SAINT JOHN NEUMANN CATHOLIC PARISH SITE PLAN AMENDMENT NO. 81981046A

PLAN TYPE:
NO. 81981046A
COMPLETED: 12-30-2021

MCPB
Item No. 3
1-13- 2022

FIRE DEPARTMENT
APPARATUS ACCESS PLAN
ADDITION TO SAINT JOHN
NEUMANN CATHOLIC
PARISH
C2.40
PROJECT NO. 80.138.34
SHEET NO. 1 OF 1

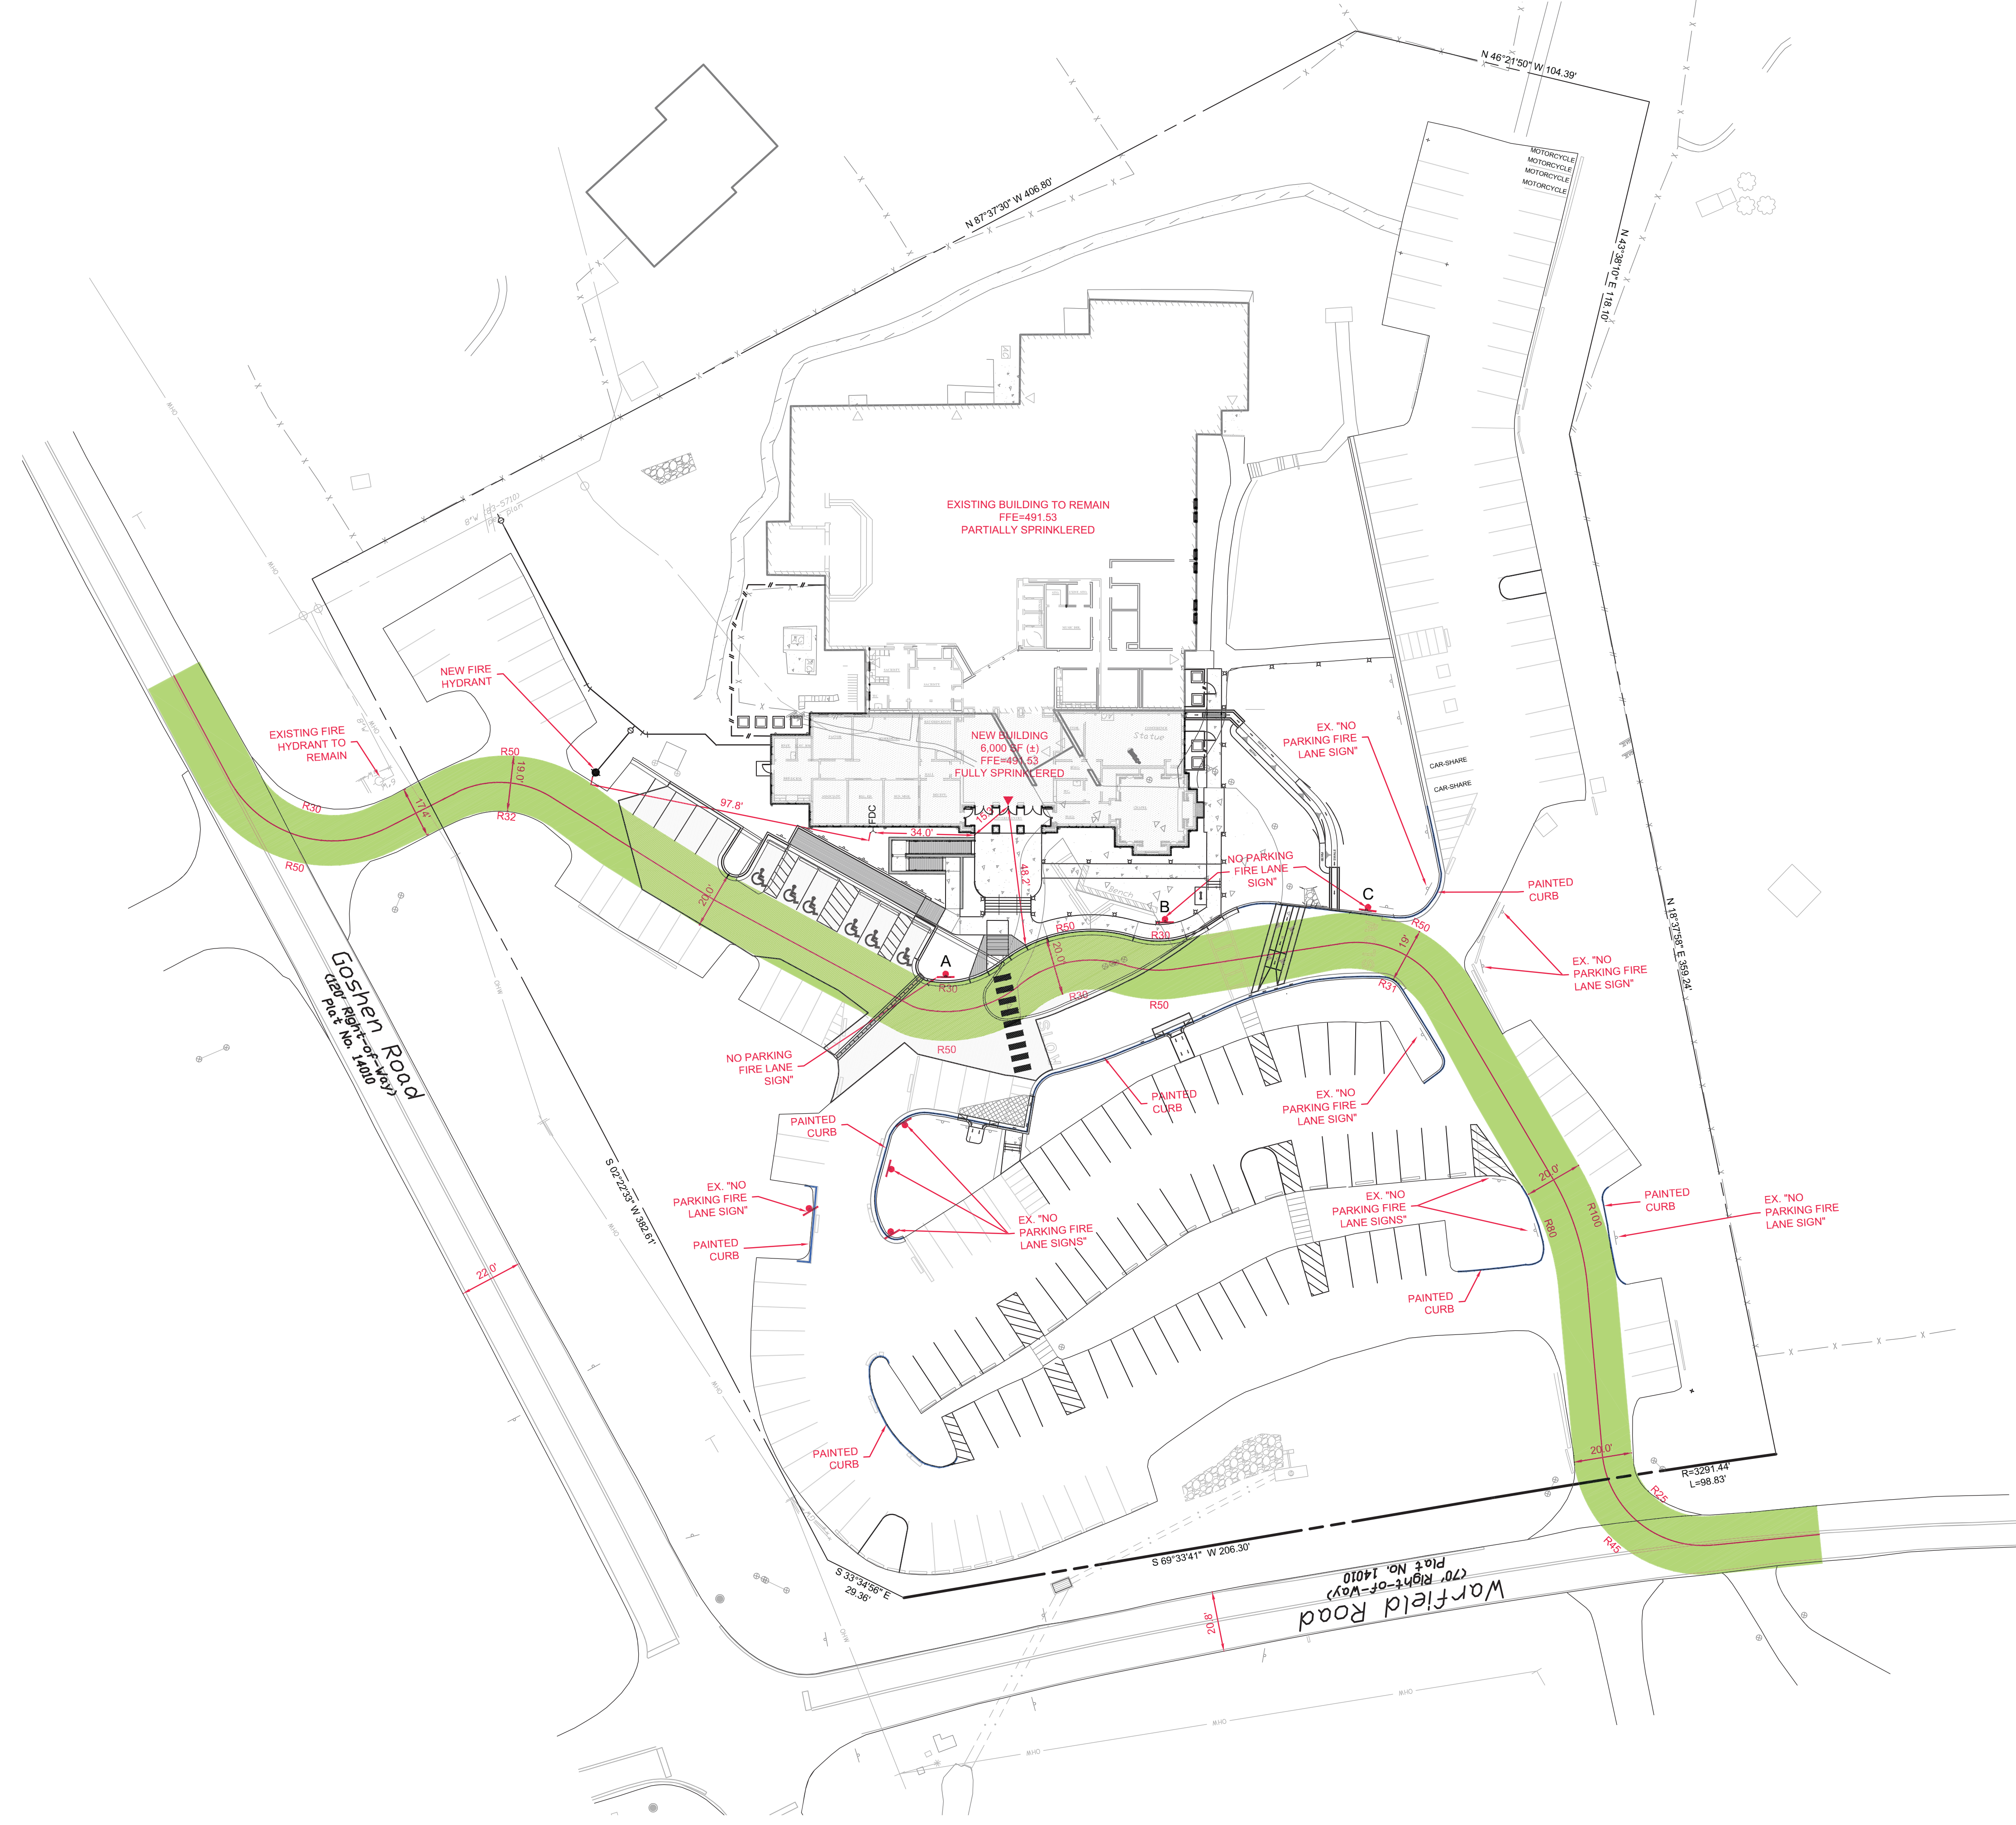
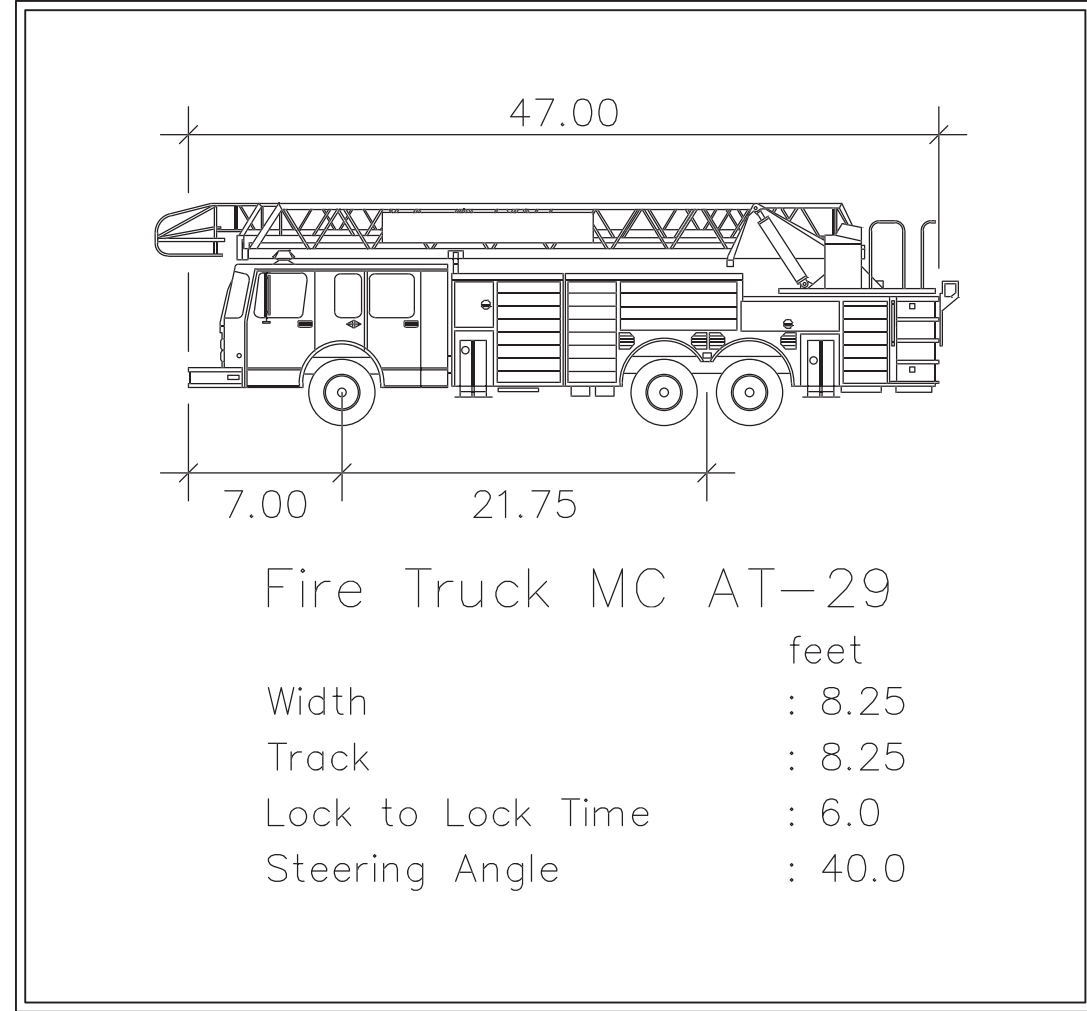
FIRE CODE ENFORCEMENT
Fire Department Access Review
Review based only upon information contained on this plan. Does not cover unsatisfactory layout resulting from omissions, errors or failure to clearly indicate conditions on this plan. Correction of such unsatisfactory layout to afford required access will be required if found upon inspection after installation.
BY: *S.M.C.* PW. 43 DATE: 2/21/2021

*** New building - see statement of performance based design for access to existing building ***
